Mt Arthur Coal

**Response to Submissions
Environmental Assessment
Proposed South Pit Extension
Project**

November 2007

Project Director:	Barbara Crossley	
Project Manager:	John Merrell	
Report No.	2000/R06/FINAL	Date: November 2007

FIGURE 2.1

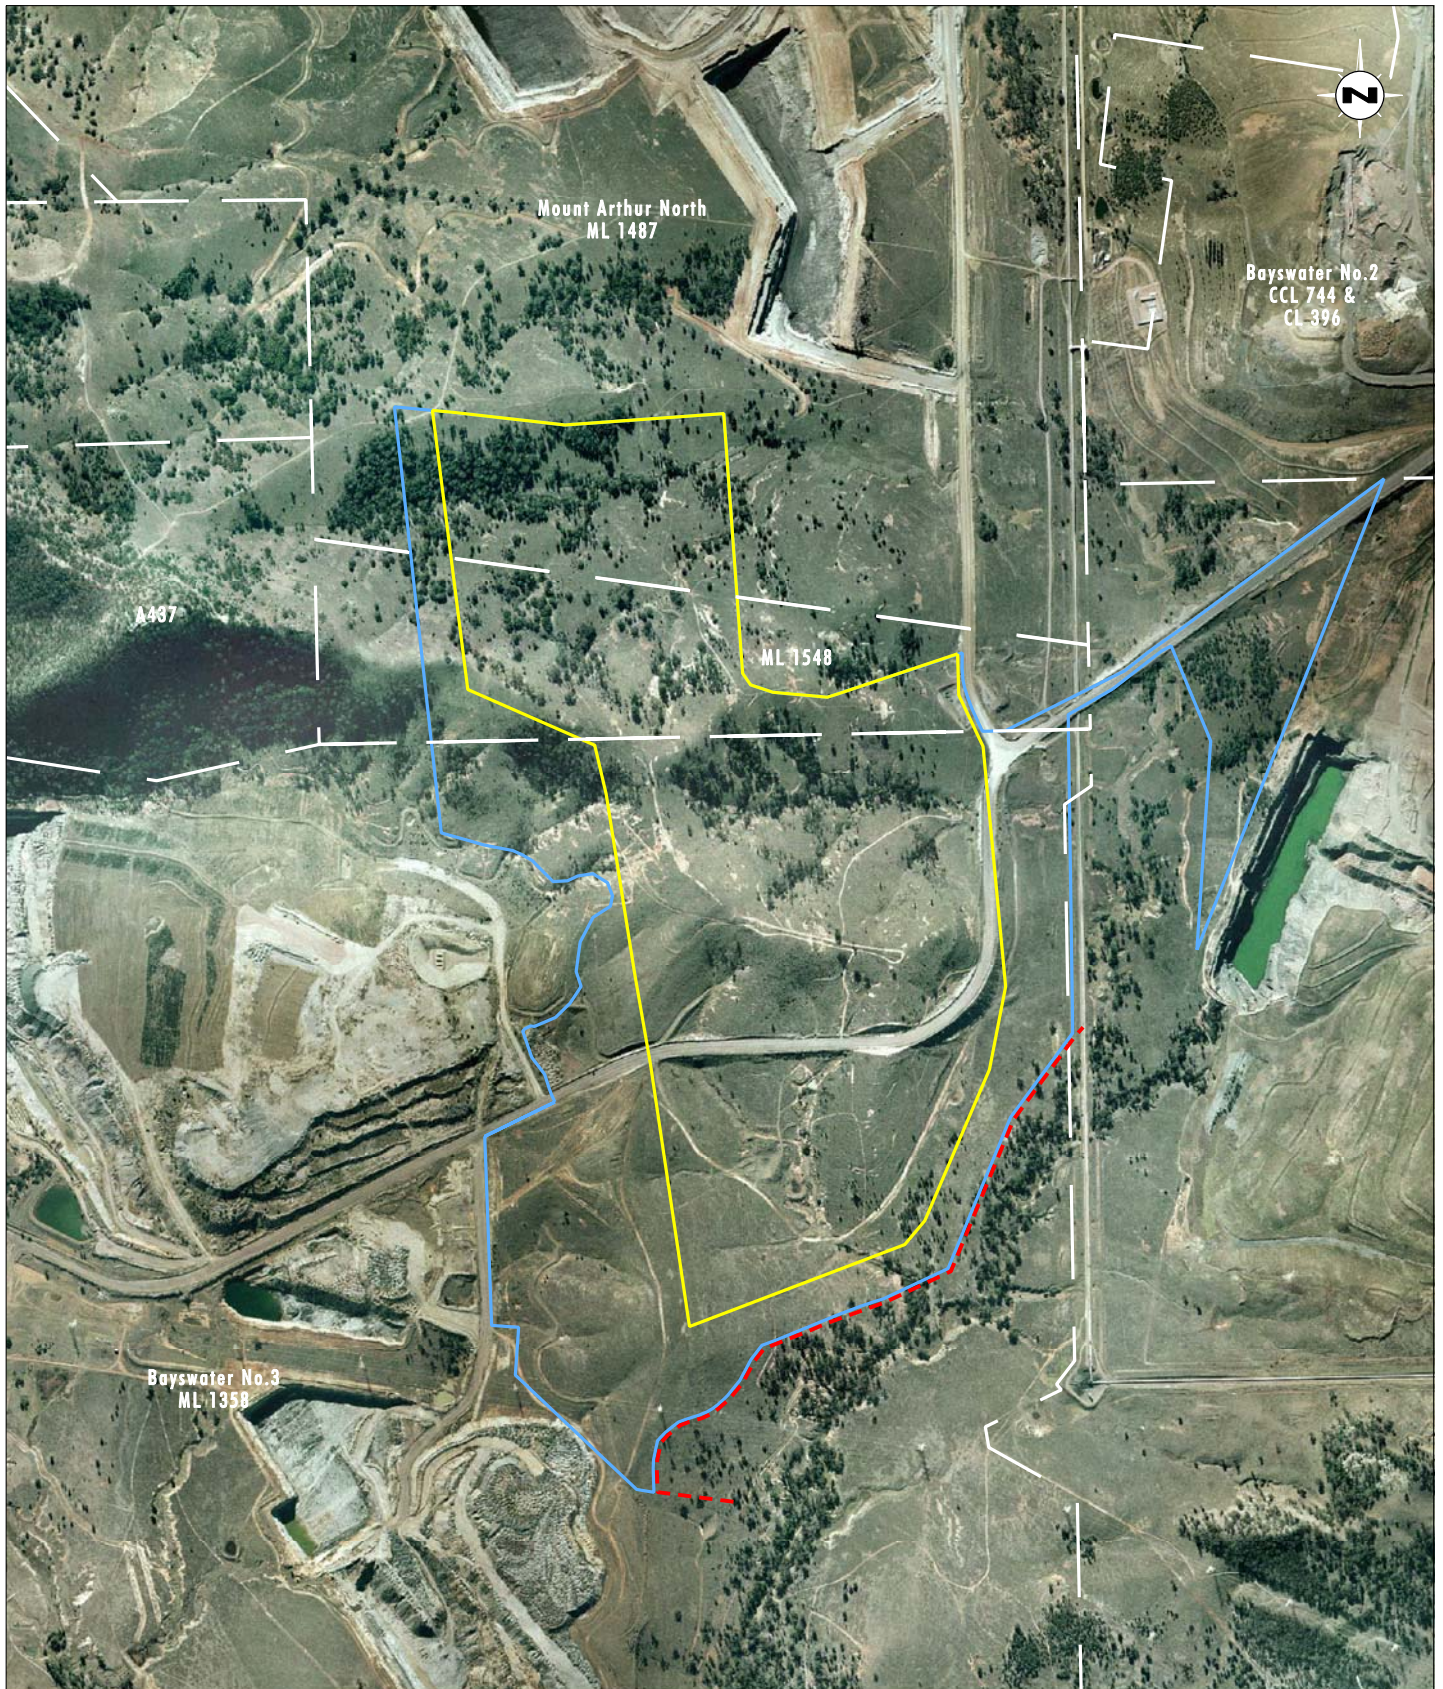
- 2. The identification of the boundaries of the buffer to be established to protect the conservation area located at Saddlers Creek and management of the area of disturbance to ensure that no unauthorised impact on this area is possible.***

To provide further clarity regarding this commitment, the proposed boundary is shown on **Figure 2.1**. The buffer zone includes all riparian vegetation along Saddlers Creek to the south of the project area and outside of the 'Approximate New Disturbance Footprint' discussed in the EA and shown on **Figure 2.1**. Commitment 6.10.1 has been revised in the Statement of Commitments contained in **Appendix 1** and now states:

'Saddlers Creek near the project area (as defined in Figure 2.1 of the Response to Submissions report, November 2007) will be fenced off to protect the riparian corridor and encourage natural regeneration. Cattle grazing (other than as a land management tool) will be excluded from this area'

FIGURE 2.2

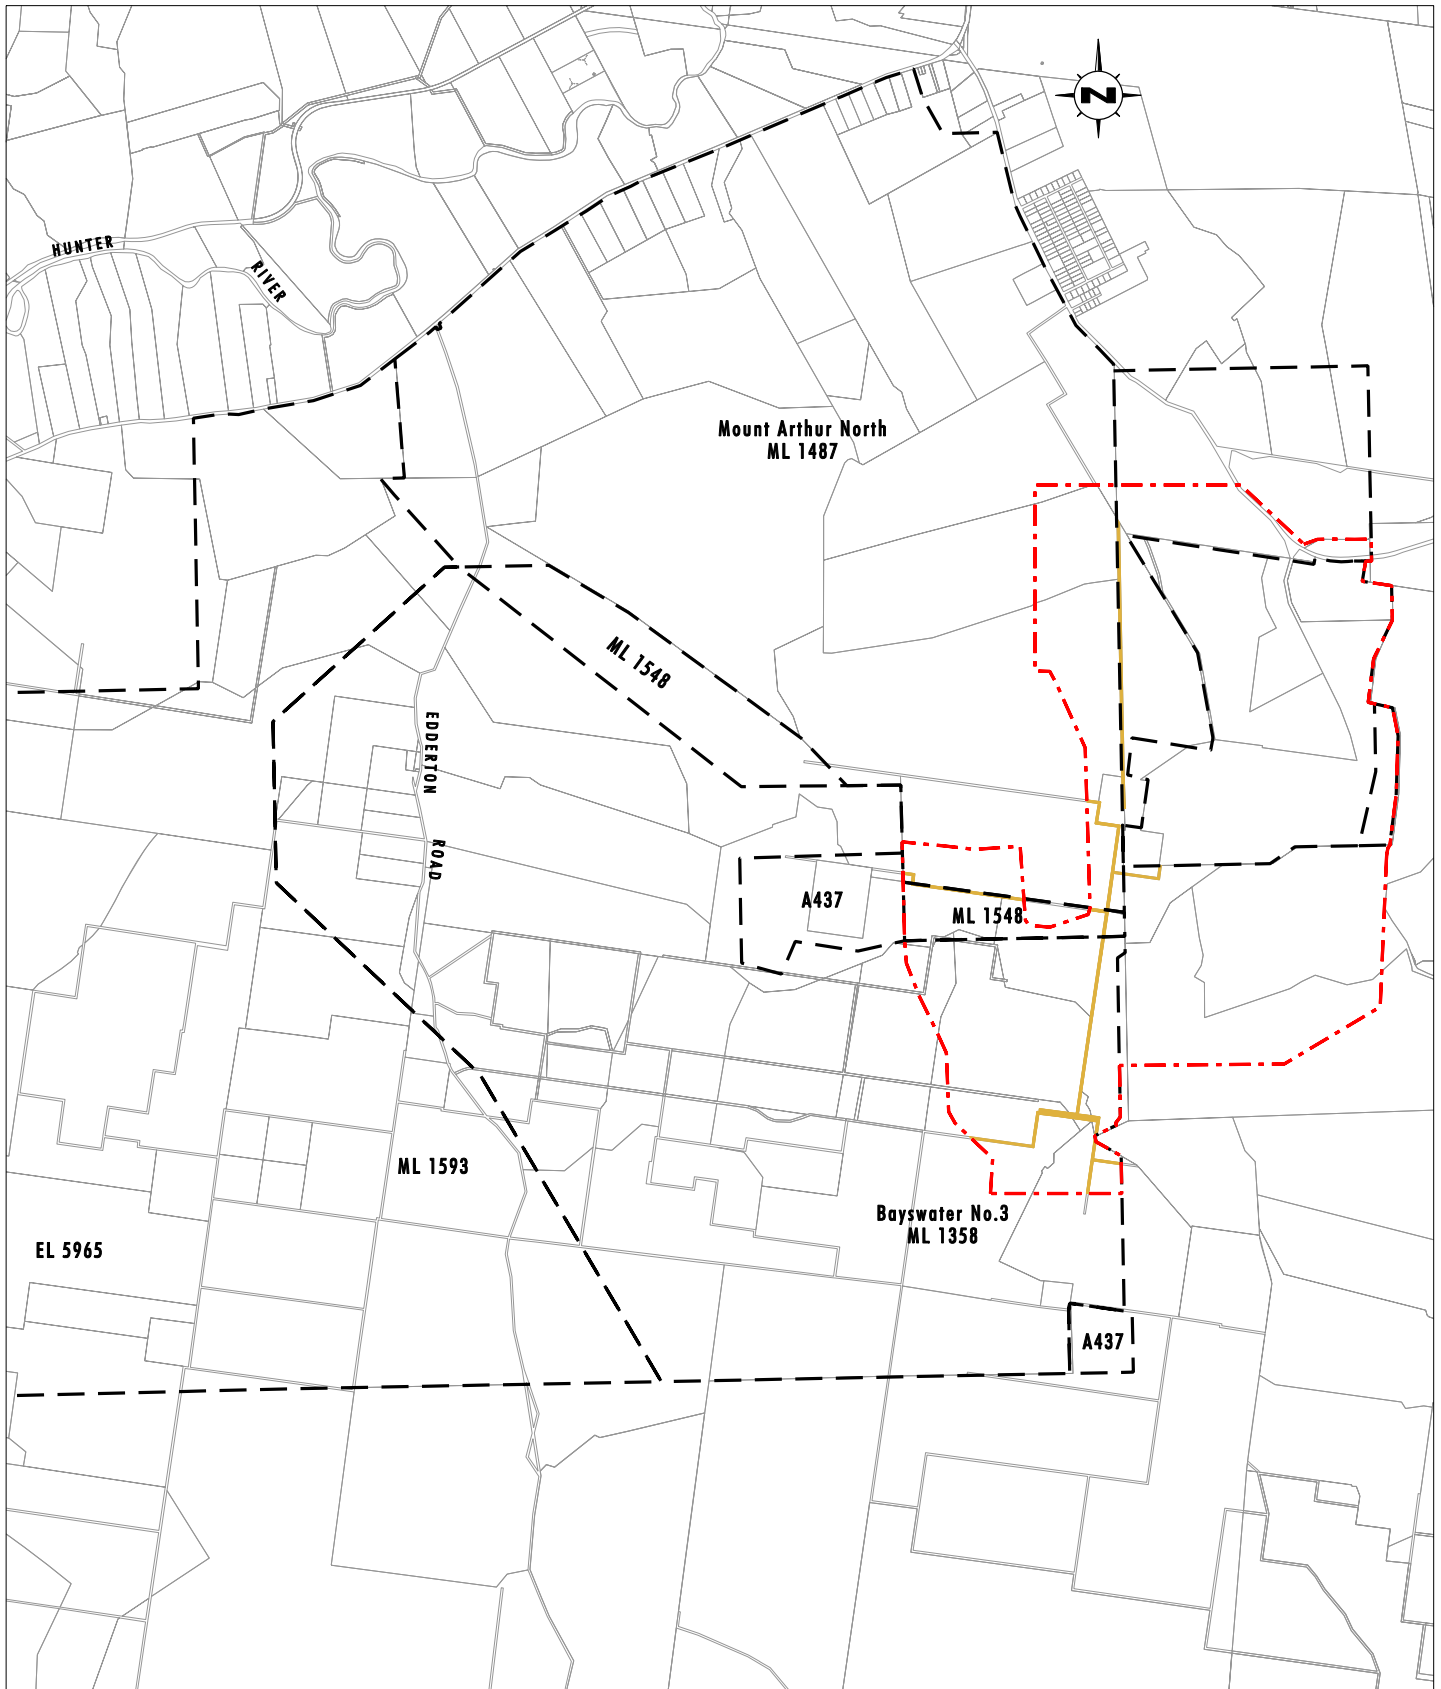
There are some discrepancies in the affected lands being identified as Crown lands. Figure 5.8 purports to identify those Crown lands involved (i.e. public Crown roads) but does not identify all such roads. There are additional Crown roads over and above those within Figure 5.8. The Departments preferred option is for the Mining Company to close, purchase and obtain title to the roads involved. The Department requires that closure of these roads be included as part of the Development Consent.

Figure 5.8 in the EA (Noise Assessment Locations) identifies areas of crown land, including some Crown roads. **Figure 2.2** shows all Crown roads within the Project Application Area. Section 4.1.2.9 of the EA notes that the approval of the Minister for Lands will be required for the closure of Crown Roads in the project area. Discussions were held with the Department of Lands during the preparation of the EA regarding the proposed closure of these road reserves.

Mt Arthur Coal will apply to the Department of Lands to close the Crown road reserves within the project area. The revised statement of commitments contained in **Appendix 1** has been modified to include a commitment regarding the closure of road reserves within the project area as detailed below:

- 6.16.1 Mt Arthur Coal will apply to the Department of Lands to close the Crown road reserves within the project area.
